Schedule 1 to the Minutes of the Public Hearing meeting of Richmond City Council held on Monday, June 17, 2019.

From: Brownlee,David
Sent: Monday, 17 June 2019 16:02
To: 'Abraham and Janice Chan'; CityClerk
Cc: Smith,Suzanne; Lee,Edwin; CityClerk
Subject: RE: Written Comments for Richmond Zoning Bylaw 8500, Amendment Bylaw 9983 (RZ 17-794287)

Please ensure the following questions are incorporated to the Public Hearing meeting agenda for the proposed rezoning for applicant 1132865 BC LTD regarding the Richmond zoning Bylaw 8500, Amendment Bylaw 9983 (RZ 17-794287) affecting the neighbourhood of 7464, 7480, 7500, 7520, 7540, 7560\7580 and 7600 No. 1 Rd on Mon. Jun. 17th at 7pm.

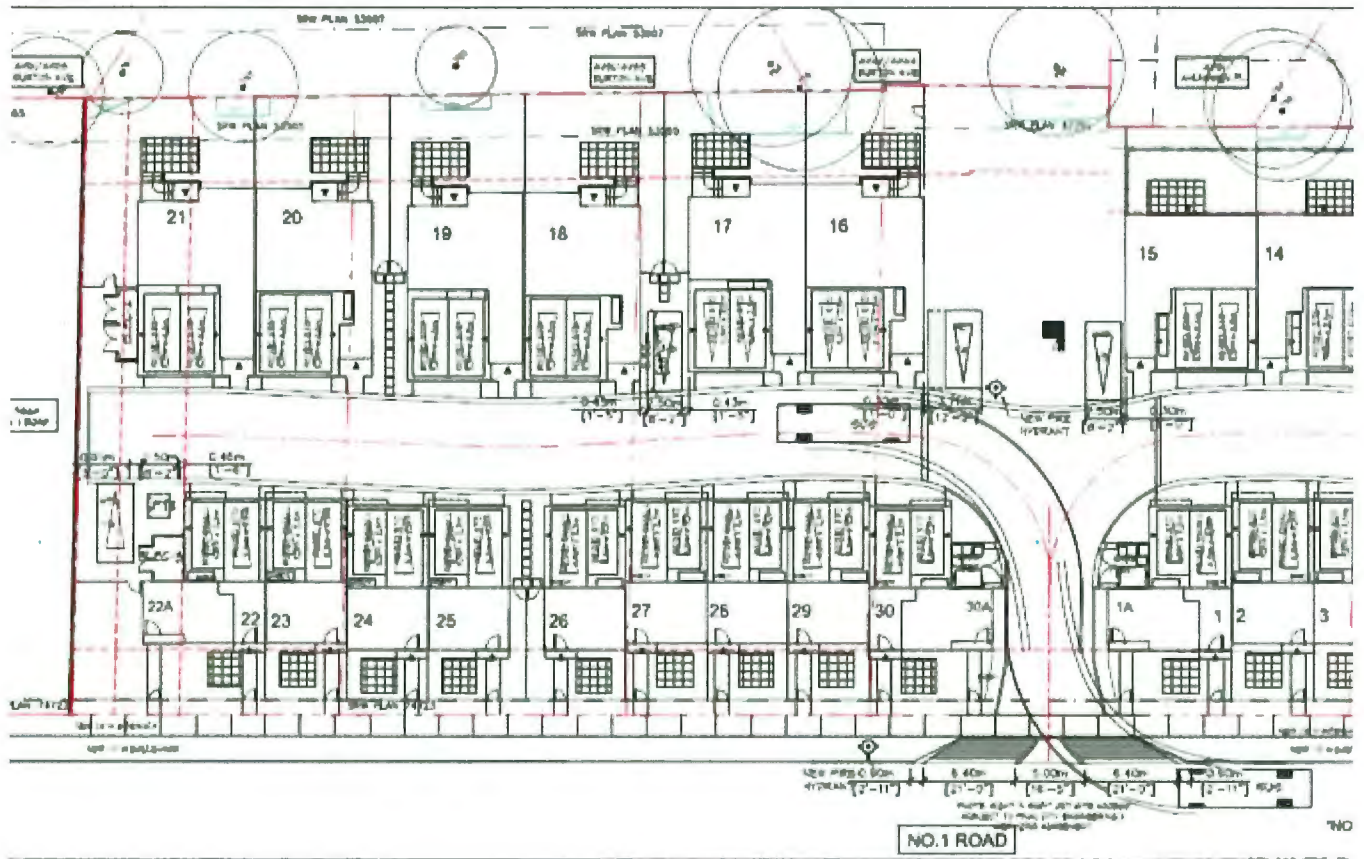
6. What will the layout of the 30 townhouse units and 3 lock-off suites look like on the proposed rezoning? Where will the entrance off No. 1 be located?

Lockoff suites are Units 1A, 22A, 30A; site entry at mid-site.
